**The Wilmington International Airport
on behalf of the New Hanover County Airport Authority,
& the Arts Council of Wilmington/NHC**

Requests for Proposals

ADDENDUM #1

Issue Date: July 1, 2020

EXHIBIT A
Site 3 Elevation

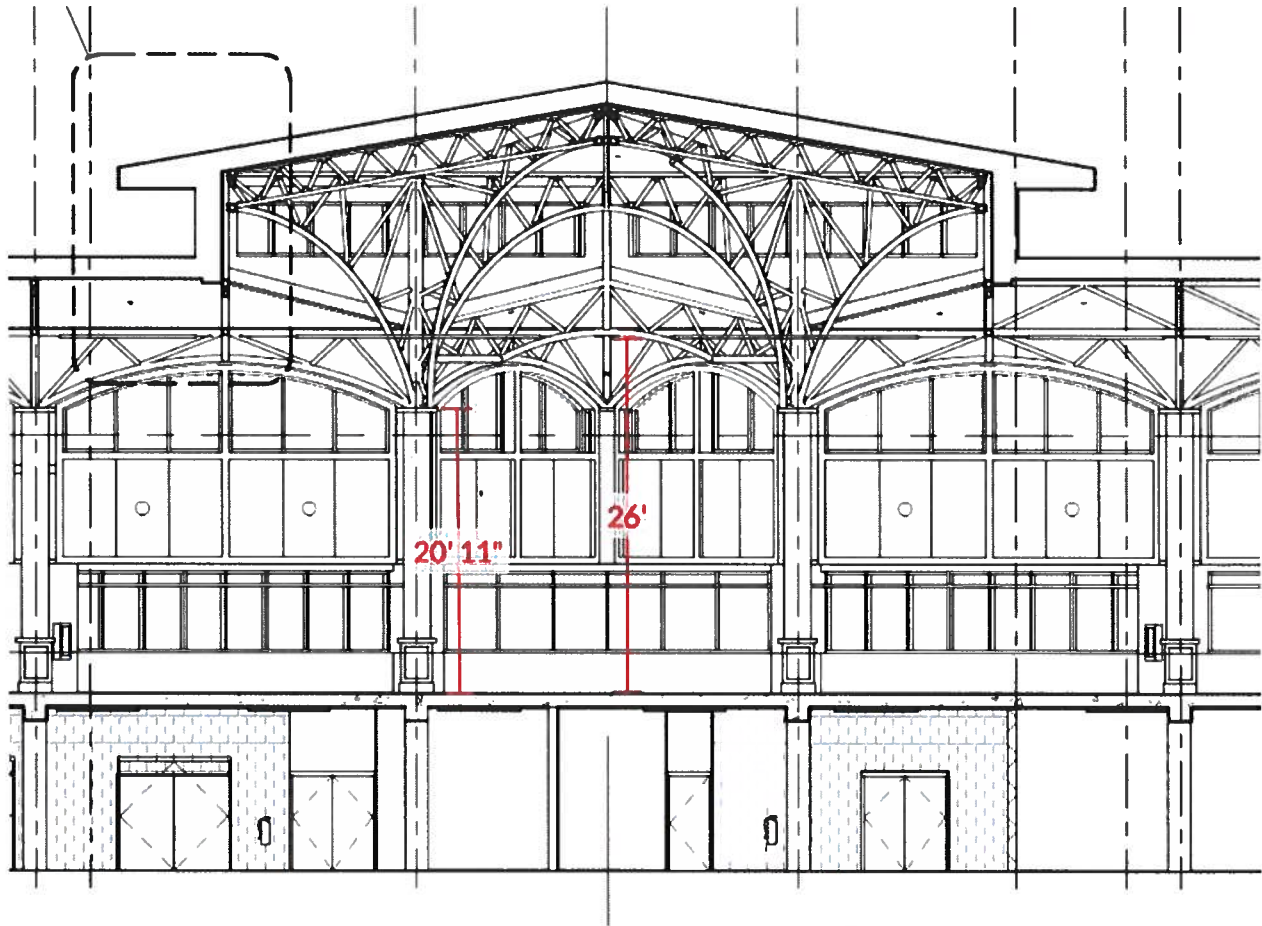
8. **Q:** For the overhead above Site 3, what is the third ideal dimension of the installation (height)?
A: Reference Exhibit A to this Addendum. Vantage across site through windows to airfield should be maintained.

EXHIBIT B
Site 3 HVAC Vent

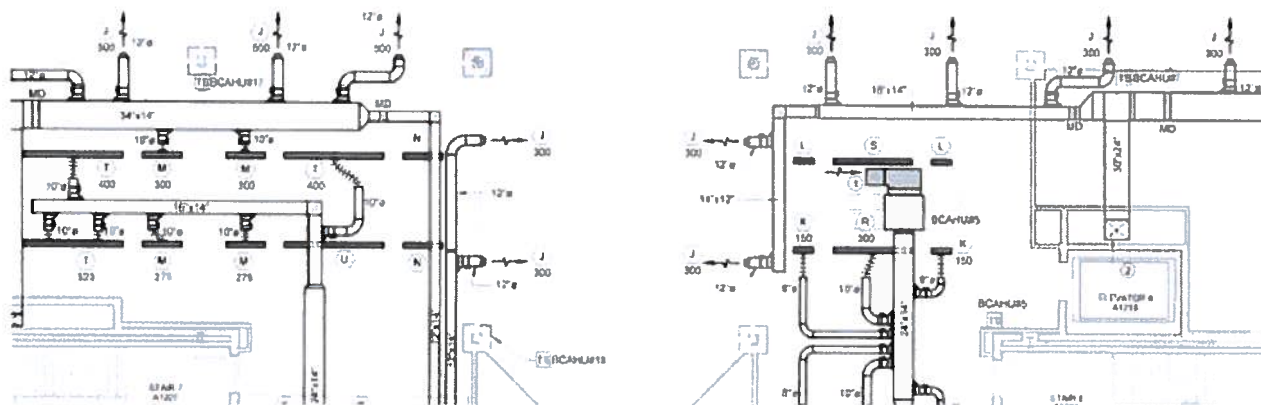
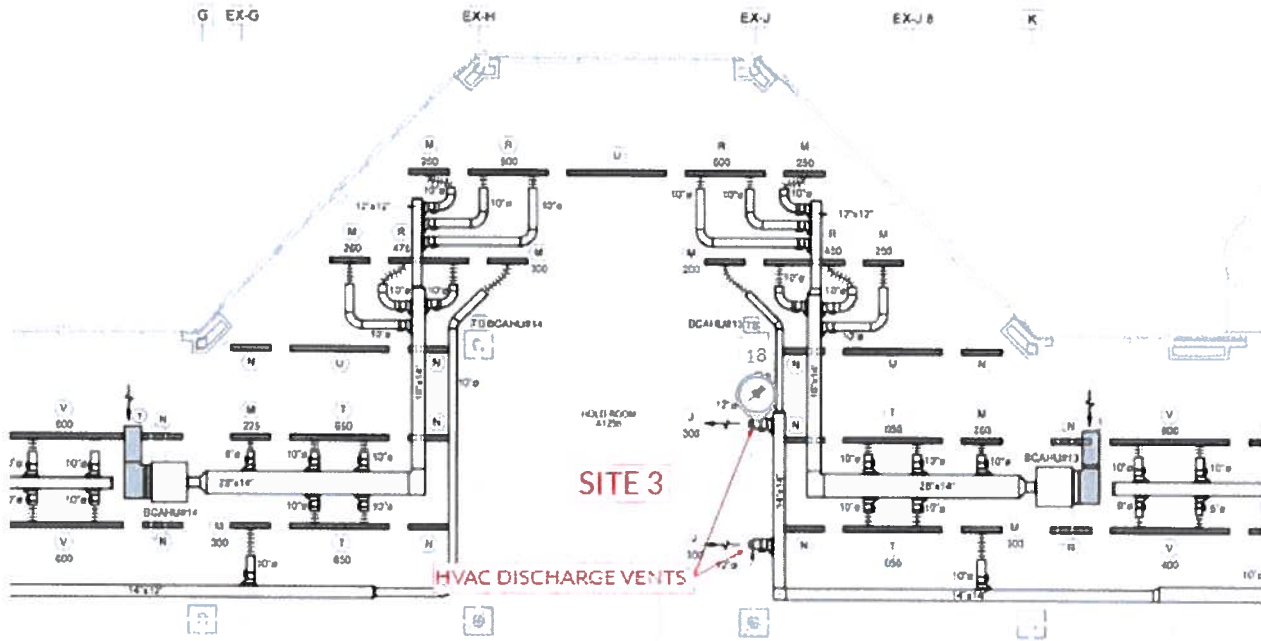
9. **Q:** Are there any near ventilation or HVAC shafts? Intake/output specs and volume would be helpful. More delicate materials will be subject to airflow variances... and that might be a lovely effect if utilized... especially when considering a natural or relaxing installation.
A: Reference Exhibit B for HVAC ductwork plans in this area.
